**Report: TAB Report**  
**Function: Test, Adjust, & Balance**  
**Date: 01/21/2026**  
**Completed By: National TAB**

**01-12-26 Wawa #7402 Indianapolis, IN**

Wawa  
260 West Baltimore Pike  
Wawa, PA 19063

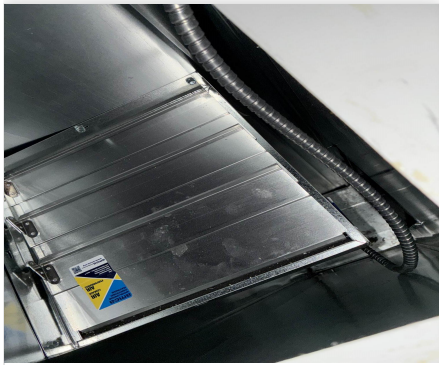
**Issue Name :** EF-1 BACKDRAFT  
**Description :** EF-1 backdraft damper too small for ductwork. This impedes TAB as it reduces total airflow. Potentially related to over-amp issue.  
**Created By :** National TAB                      **Assigned To :** National TAB - Noah Stafford  
**Status :** Open  
**Priority :** Urgent                                      **Asset Tag :**  
**Originated Date :** 01/12/2026 - Noah Stafford - National TAB

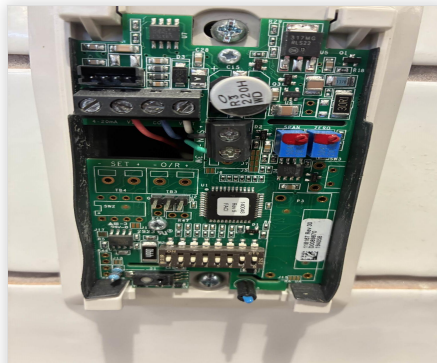
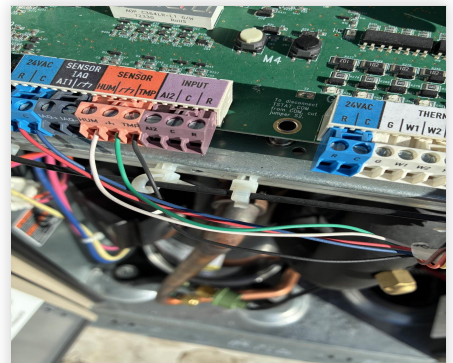
**Issue Name :** RTU SENSOR WIRING  
**Description :** RTUs use only thermostat wiring for the sensors. Design plans call for twisted pair shielded cables containing 18AWG minimum. This issue does not prevent TAB.  
**Created By :** National TAB      **Assigned To :** National TAB - Noah Stafford  
**Status :** Open  
**Priority :** Medium      **Asset Tag :**  
**Originated Date :** 01/12/2026 - Noah Stafford - National TAB
